PLANT NAME: Oconee Unit 1

Reference: Oconee Unit 1
Docket No. 50-269

Pursuant to 10CFR50.90, an amendment is requested to Oconee Nuclear Station Facility Operating Licenses DPR-38, -47 and -55 to delete the existing reactor core quadrant power tilt and control rod position limits for Oconee Unit 1 specified in Technical Specifications 3.5.2.4.a and 3.5.2.5.c. The attached Technical Specification revision pages indicate those more conservative limits which will be instituted. The justification for this action is provided in Attachment 2 to this letter.

PROPOSED TECHNICAL SPECIFICATION REVISION

FIGURE 3.5.2-6A1

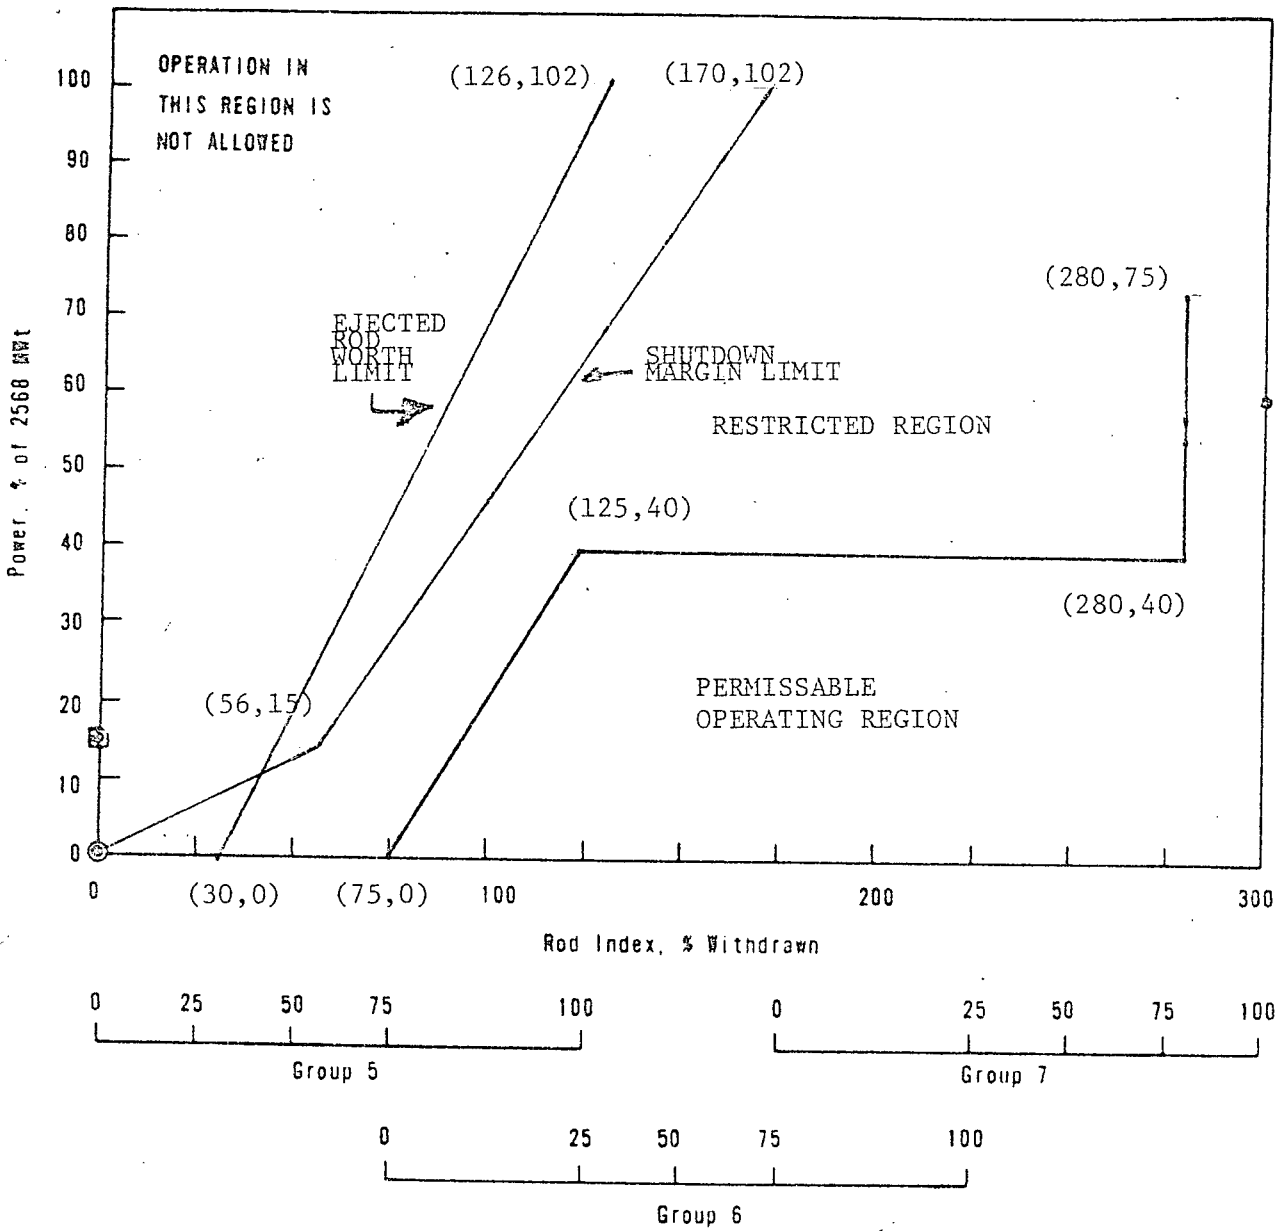
3.5.2.8 For Oconee Unit 1, in the event Specifications 3.5.2.4.a or 3.5.2.5.c are not met, operation shall be restricted as follows:

- a. The core thermal power shall be limited to 75 percent full power.
- b. The nuclear power maximum setpoint shall be 84 percent full power.
- c. The quadrant tilt shall not exceed 6.03 percent.
- d. The regulating control rod insertion/withdrawal limits are specified on Figure 3.5.2-6A1

If any of the above provisions are not met within two hours, the reactor shall be in the hot shutdown condition within an additional 4 hours.

The operating limits provided in the proposed Technical Specification 3.5.2.8 are based on both analysis and measured data. The analyses which established the current quadrant tilt and rod position limits in Specifications 3.5.2.4 and 3.5.2.5 were based on a maximum quadrant tilt of 3.41%, which would produce a maximum power peaking increase of 5.1%. The provision to operate at up to 6.03% quadrant tilt would produce a maximum power peaking increase of 9.0%, or 4% more than originally considered. However, the imbalance limits in Specification 3.5.2.6 applicable to Oconee I, Cycle 4, for the period of 0-100 + 10 EFPD are quite conservative below 90% of full power. Based on maintaining the limits of 3.5.2.6 at and below 75% of full power and on maintaining the rod position limits of 3.5.2.8, the maximum clad temperature in the event of a LOCA will not exceed the Final Acceptance Criteria.

The rod position limits of 3.5.2.8 also provide that the shutdown margin and ejected rod worth criteria are met. The measured hot zero power values of the worth of banks 5-7 and the ejected rod were compared to the predicted values, and the most conservative set of values were used to determine new shutdown margin and ejected rod worth insertion limits. Figure 3.5.2-6A1 shows the interim rod position limits and the shutdown and ejected rod worth insertion limits derived as described above.
